CODE: R-465

DATE: August 13, 2001

SUBJECT: Deck Lift Shaft Assembly

MODELS AFFECTED: 600 and 800 Series Pedal Drive Step Thru Frame Models w/ 42", 46" and 50" Decks

Figure 1

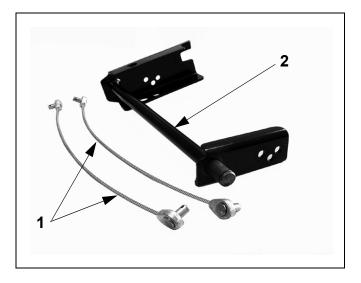
Use this service kit when Deck Drive Belt loss is experienced while cutting in the lowest cutting position. The lowest cutting height is approximately 3/4 inches. Installation of this kit will result in correcting the lowest cutting height from 3/4 inch to 1 1/2 inches in accordance with engineering design. The corrected cutting range will then be 1 1/2 to 3 1/2 inches.

When connecting the Lift Cables to the Lift Shaft Assembly ensure the correct hole is used in accordance with the hole identification stamped in each cable attach bracket and Figure 1.

Position "46LT" is for Lawn Tractors w/ 46" deck and either manual or electric PTO.

Position "42" (middle hole) is for Lawn Tractors w/ 42" deck and manual PTO only.

Position "GT" is for all Garden Tractors w/ 46" and 50" decks and either manual or electric PTO.
